Subject: AP1000 Response to Request for Additional Information (SRP 19)

RAI-SRP19.0-SPLA-20

Response to Request for Additional Information on SRP Section 19

RAI Response Number: RAI-SRP19.0-SPLA-20 Revision: 0

Revision to Figure 8.3.1-3.

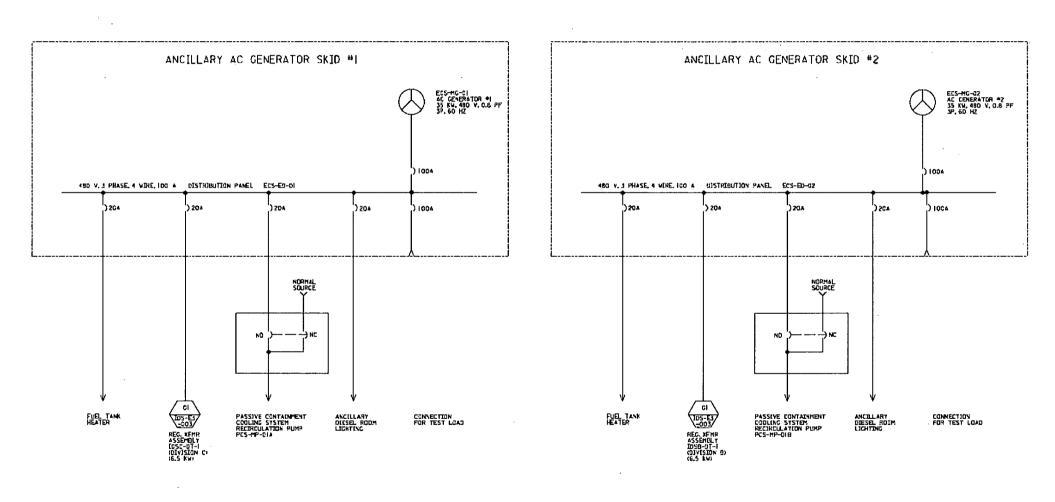
Also attached is a change to Figure 8.3.1-3. As was pointed out by the reviewer there are notes in the DCD Rev 17 Figure 8.3.1-3 and no description as to what those notes mean. The notes have been deleted from the Figure.

There were references to notes in the DCD Rev 17 Figure 8.3.1-3 and no description as to what those notes meant. The references to the notes have been deleted from the Figure.
